Impact Assessment Agency of Canada

ANALYSIS OF MARATHON GOLD'S PROPOSED CHANGES TO THE
VALENTINE GOLD PROJECT (THIRD PIT)

JUNE 2024

Figure 1. Proponent's Proposed Changes to Project Components and Layout.

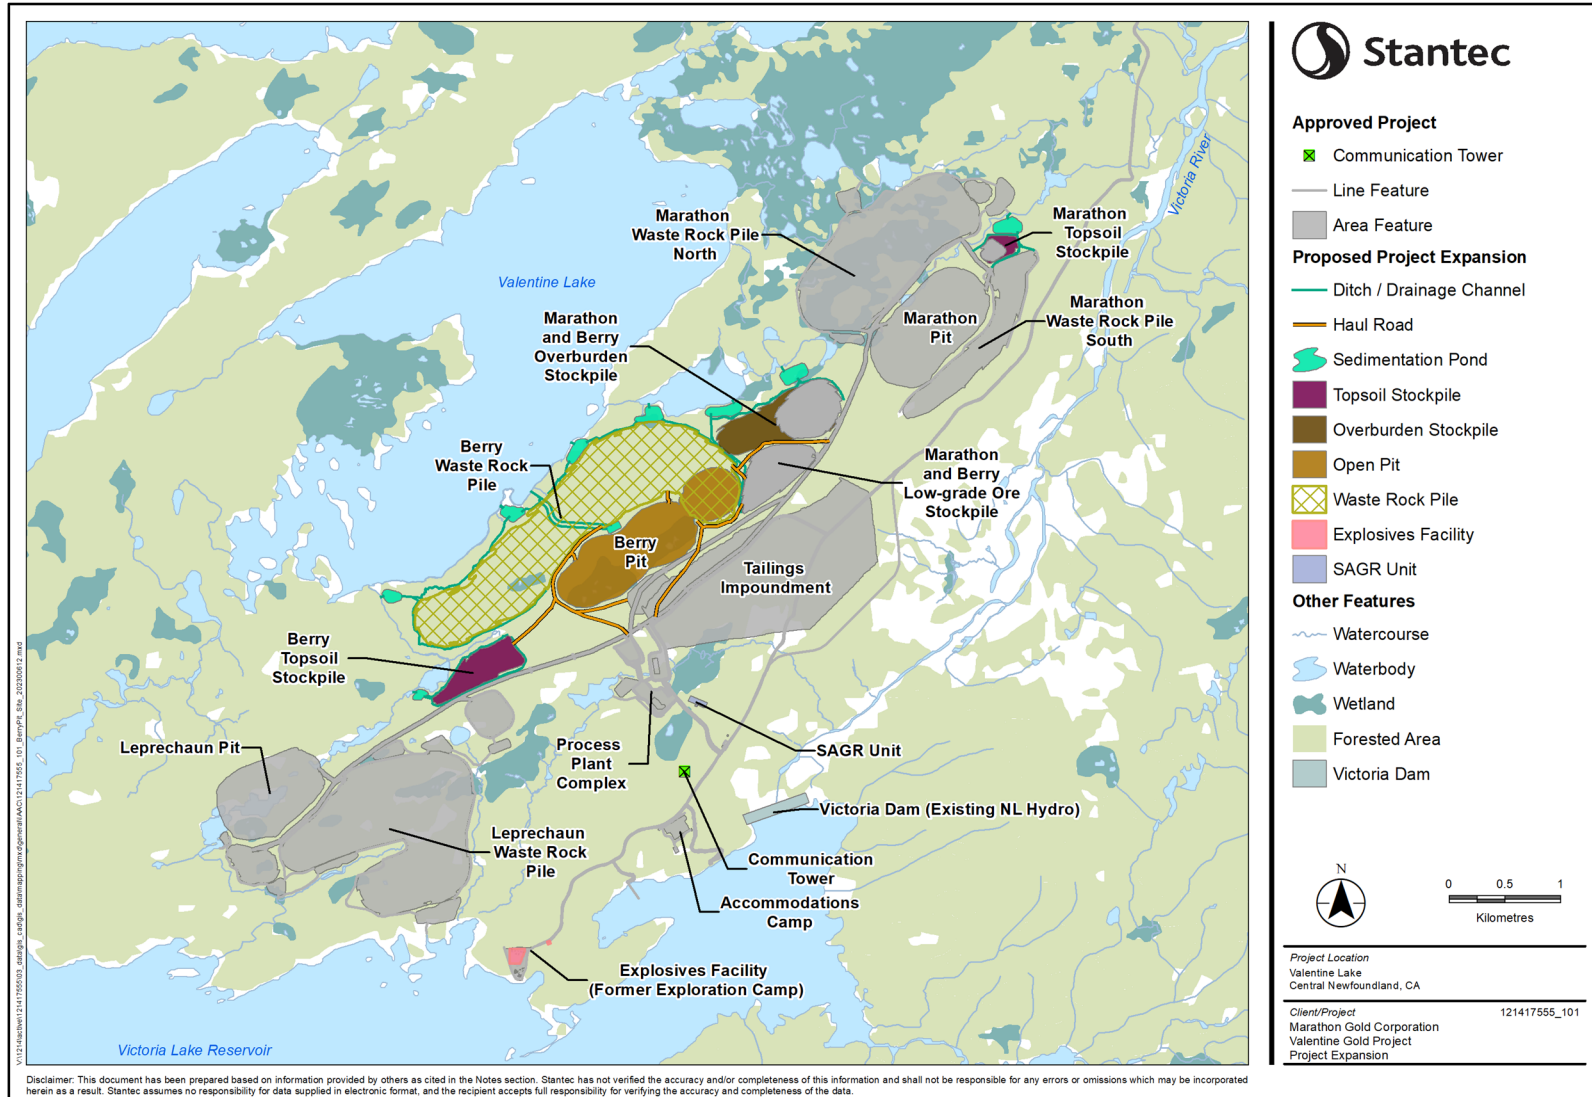
Following additional analysis of the mineral resources within the Leprechaun and Marathon pits described in the 2022 Environmental Assessment Report, the proponent determined that the mineable resources within these pits were less than anticipated. The discovery of the Berry deposit within the existing mine site, would offset the decrease in mineable resources from the other two pits and improve the economic outlook for the Project in the face of rising costs. As a result, the proponent is proposing changes to the Project that would include the mining and processing of ore from the Berry deposit and other associated changes.

- addition of a third open pit (the Berry Pit) with new associated haul roads;
- new waste rock pile, and two additional topsoil stockpiles;
- the expansion of the Marathon pit overburden and low-grade ore stockpiles to accommodate materials from the Berry Pit;
- eight new sedimentation ponds associated with the Berry Pit, one new temporary sedimentation pond, and the relocation of a previously-planned sedimentation pond;
- the relocation of the explosives storage facility to maintain safety setbacks from infrastructure;
- relocation of tailings disposal from the mined-out Leprechaun pit to the mined-out Berry Pit starting in year 10 of the Project;
- the replacement of the secondary water treatment technology from a polishing pond to a submerged attached growth reactor (SAGR) to improve treatment for nitrogen species.

The proposed modified layout of the mine site and the main Project components are illustrated in Figure 1. The Project area originally assessed was 3497 hectares and would expand by approximately 3.4 hectares to accommodate three of the eight new sedimentation ponds, their associated ditches/drainage channels, and the relocation of the explosives facility, while all other additional and existing Project components would be within the Project's original Project area. The original assessment assumed that all habitat within the mine site would be lost so the Project changes represents an additional 0.1% increase in area assumed to be lost. Figure 2 illustrates the new Designated Project area which includes all project components. The implementation of Project changes would begin as soon as regulatory approvals are in place, taking four to six months to construct and increasing the overall operation phase of the mine by approximately 1.4 years without increasing the annual ore production.
